1. **Case #H 05-84** 815-817 E. Alameda. Downtown & Eastside Historic District. Duty & Germanas, agents for Abruzzo Development, propose to construct streetscape yard walls between 3' and 4' high, side and rear lot line walls and coyote fences between 5' and 6' high, and additional hardscaping, landscaping, and lighting fixtures.

CASE # H-05-84

DEVELOPMENT PLAN

SANGRIA COMPOUND

1 PROPERTY ENTRY-STREET FACING WALL
 SCALE: 1/8"=1'-0"

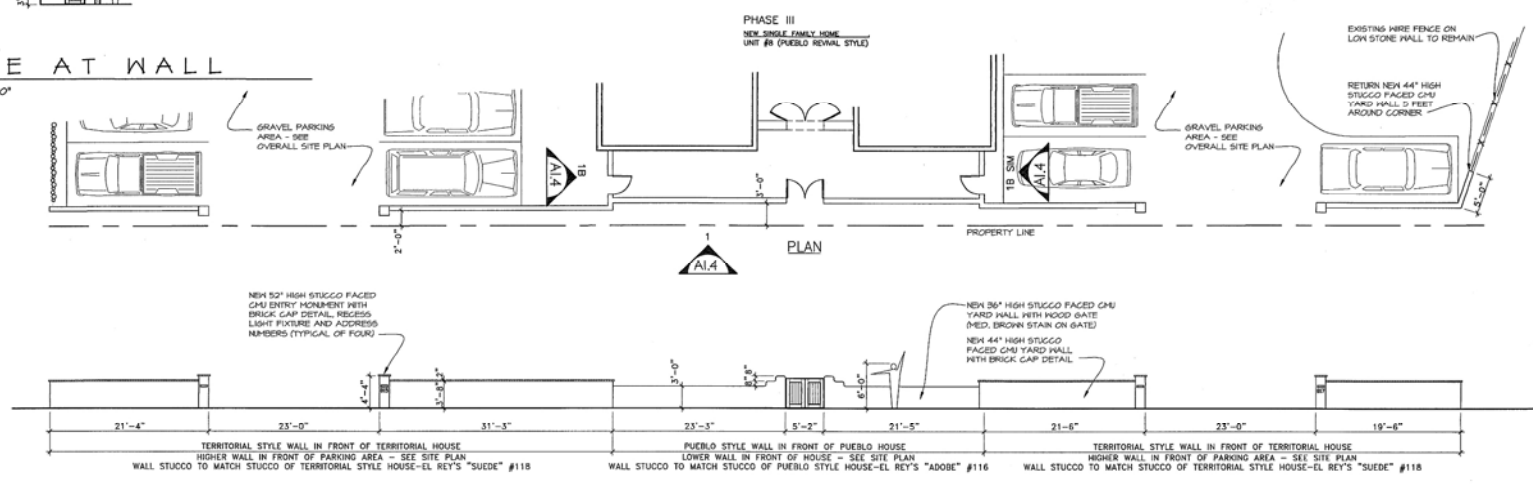
Ms. Shapiro asked about the wall that faced East Alameda. She said they only had somewhat of an elevation.

Ms. Shapiro wished she could see it in relation to the building. She asked for wall detail. She asked if part of it would have a Territorial top.

Ms. Shapiro asked if where it stepped down, it would have a little bump out.

Ms. Shapiro asked if it would be thicker by the gate.

Mr. Bell asked if the 8" step would be up or down.

Staff recommends an 8" height change for the 31' 3" section of the streetscape wall in front of Unit 1, otherwise staff believes that this application is in compliance with Section 14-5.2 (E) Downtown and Eastside Design Standards and recommends approval.

4. The streetscape wall facing Alameda Street will vary in style according to the style building it fronts. The 3' 8" high (where the maximum allowable is 4' 5") streetscape wall in front of Unit 1 which runs 21' 4" long in one section, breaks for 23' for entry, and runs another 31' 3" long will be Territorial in style. It will be stuccoed in El Rey "Suede" and have a brick capping to match the contributing building. The 31' 3" long section requires an 8" height change at 25'.

Mr. Duty agreed and said the rest would be rounded stucco. He said the tops would be completely rounded.

Mr. Duty agreed. He said the wall stepped back and down.

Mr. Duty agreed, saying it would be a pilaster.

Mr. Duty said it was not a great idea to step it down at all. He said they would do it to stay in conformance. He said it made more sense to build it as drawn.

Ms. Farr moved to approve Case #H 05-084 as drawn. Ms. Shapiro seconded the motion and requested that the Pueblo wall be rounded on top as testified. Ms. Farrar agreed and the motion passed by unanimous voice vote.

This is to certify that the Historic Design Review Board (HDRB) at their meeting on May 9, 2006, acted on the above referenced case. The decision of the board was to approve your application as submitted with the condition that the Spanish Pueblo Revival style wall is very rounded on top.

2 LIGHT FIXTURE TYPE "B"
SCALE: N.T.S.

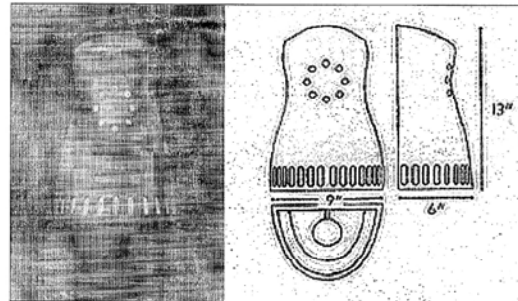
Mr. Bell asked about the blue lights along Alameda.

Mr. Bell asked if they were facing out.

Mr. Duty said they were in the pilasters. He said they were the fixture type labeled as B in the plan.

Mr. Duty said that was correct. He said they were primarily to illuminate the pilaster and the house numbers. He said it was a low level.
